RFP NO.: **RFP NO. ASPA24.051 – Construction of Fagaalu to Utulei ACP Replacement Project**

SUBJECT: **Addendum No. 4**

RFP NO. ASPA24.051 - FAGAALU TO UTULEI ACP REPLACEMENT

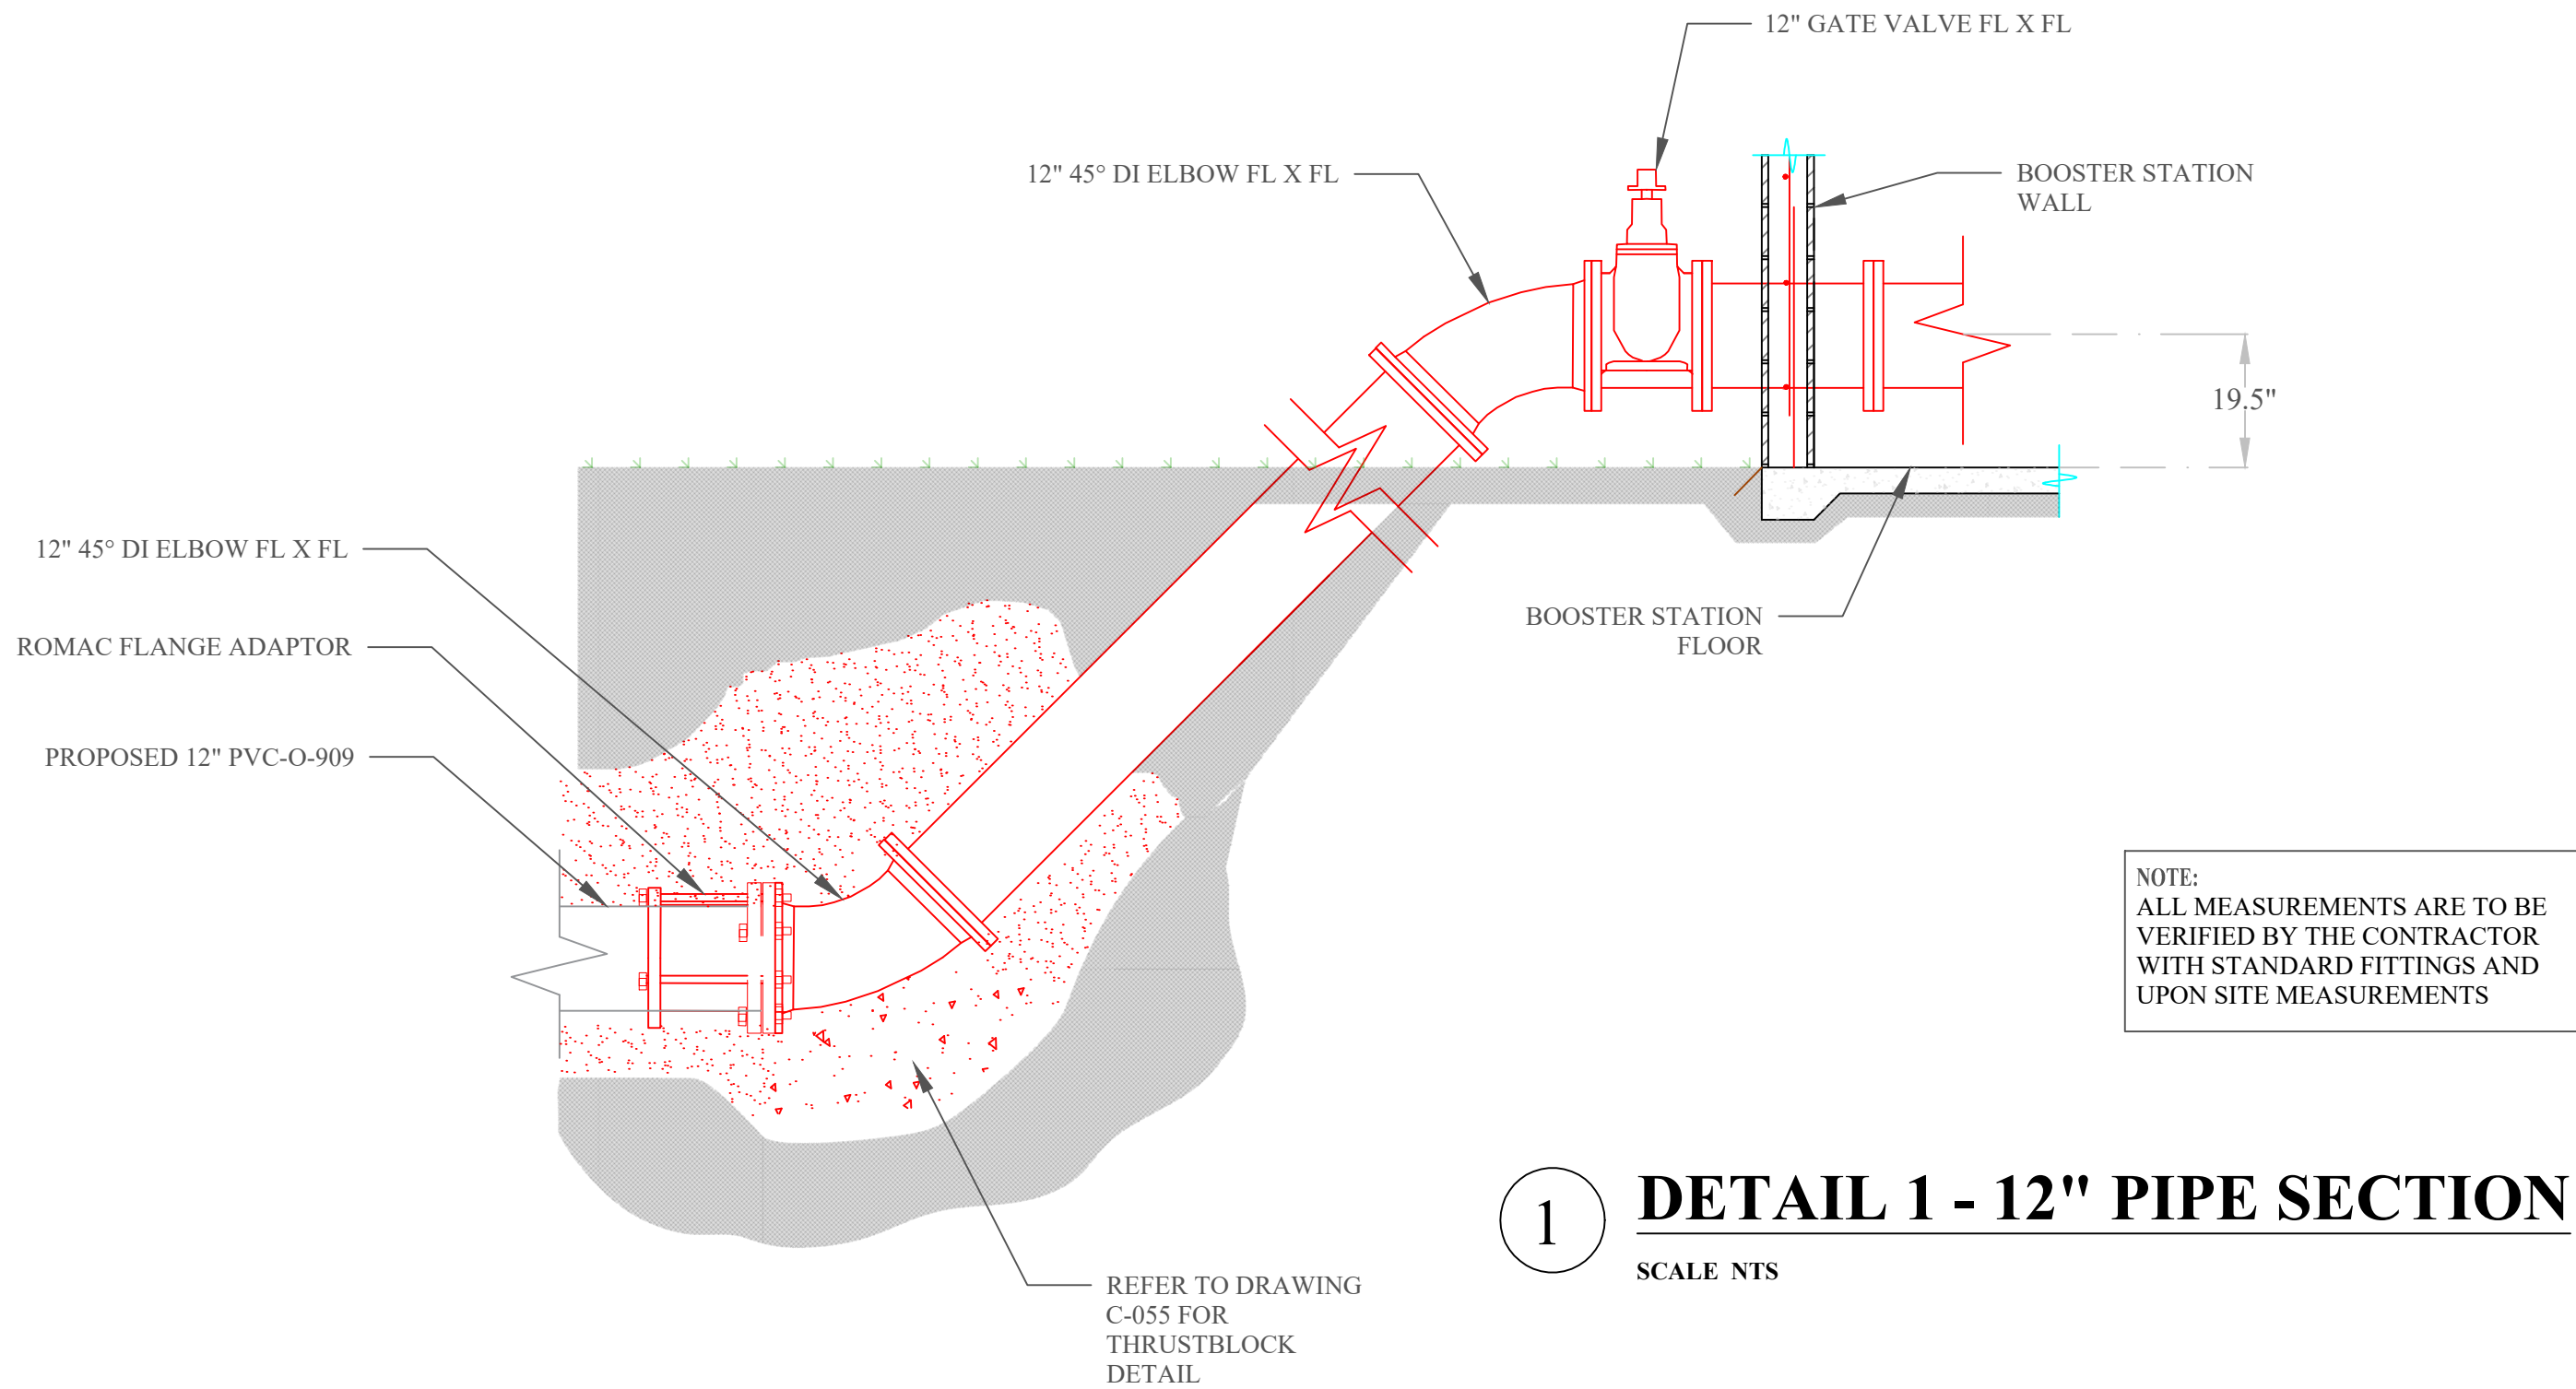
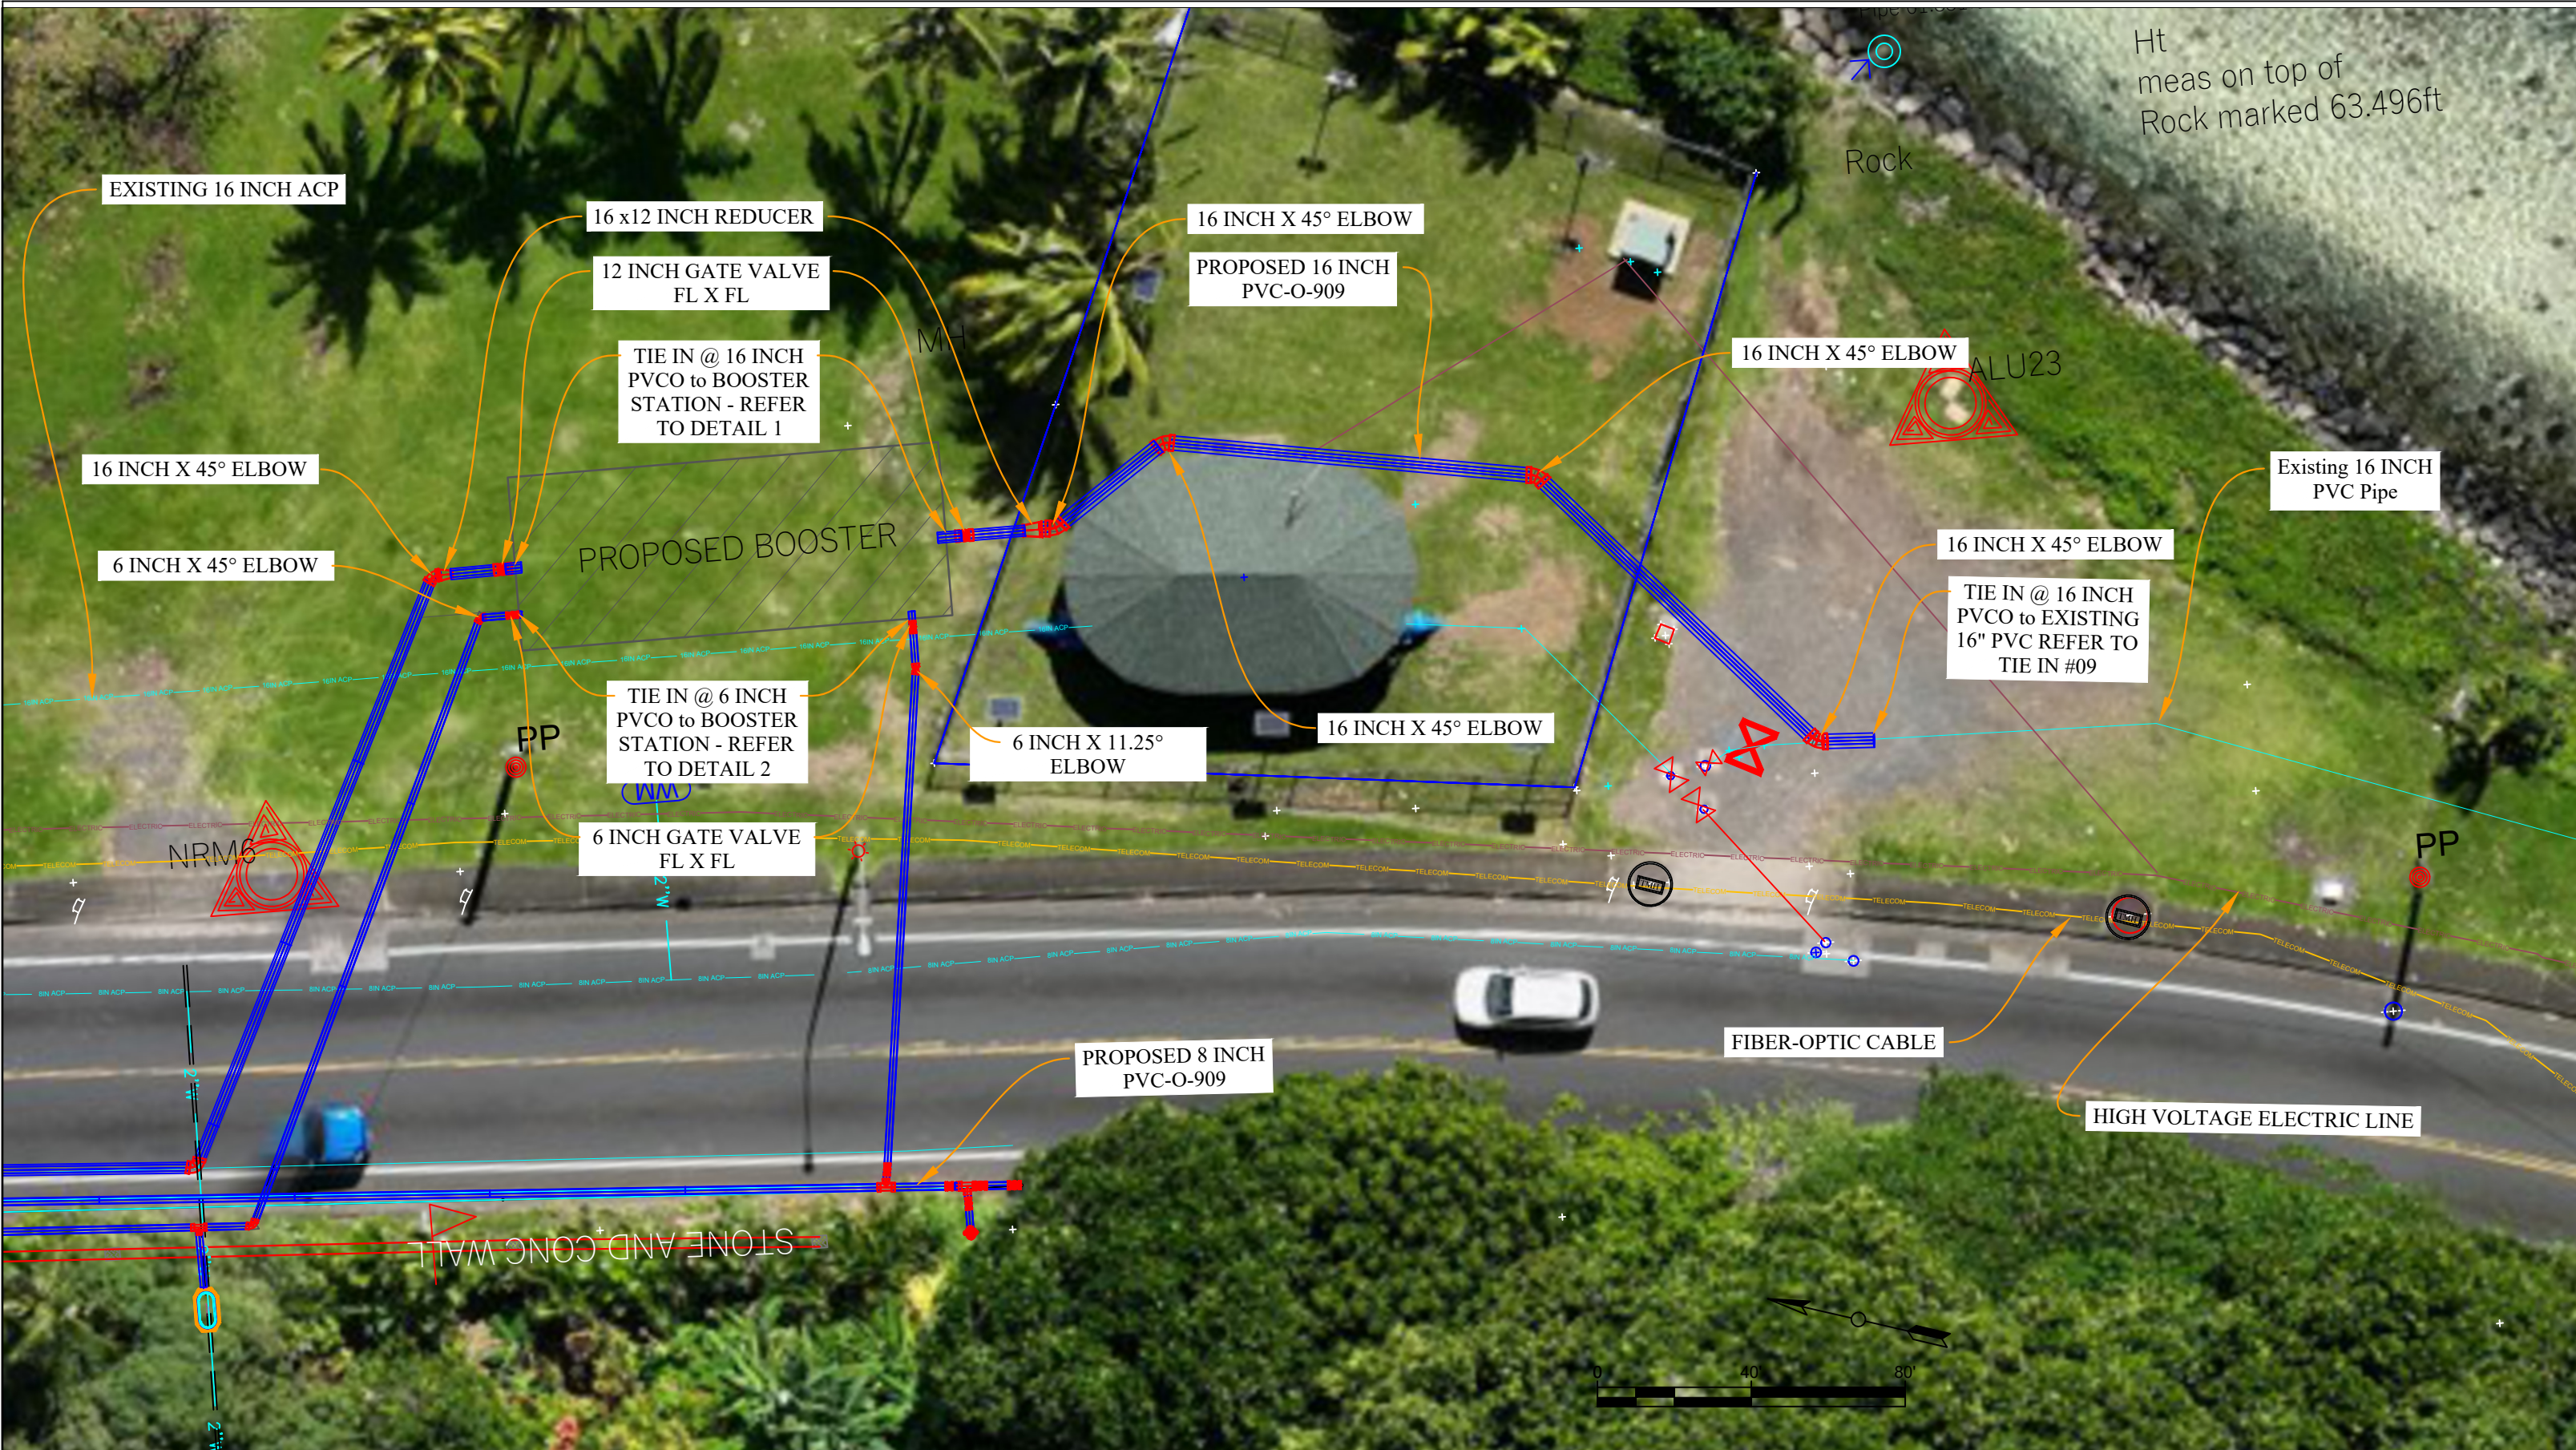
No.	Question	Answer:
1	For 3 pipes combined in 1 trench, can you please specify the separation between pipes? Detail 7 of the sheet C-057 is not clear.	See attached revised Drawing C-057
2	Can you please confirm the Blue Carsonite Marker [whether] it will be ASPA supply?	The Blue Carsonite Marker is provided by ASPA
3	On page C053, detail section A-A, Carbon Steel Ear, can you please confirm that this fitting will be ASPA supply?	The Carbon Steel Ear is provided by ASPA.
4	Scope of work item number 23, Contingency item (ii) Oil/water separator and in sheet C062 - Can you please provide vendor or structural plan detail?	Disregard Scope of Work item number 23, contingency item (ii) oil/water separator, as shown on sheet C062
5	Scope of work item number 23, contingency item (iii), HFO (Heavy fuel oil), can you please provide a model number, vendor or detailed plan?	Disregard Scope of Work item number 23, contingency item (iii), HFO (Heavy Fuel Oil)

REVISION:					
NO.		BY:	CHK:	APPD:	DATE:
1	SPACING BETWEEN PIPES	JT	FA	Y	11/08/2024
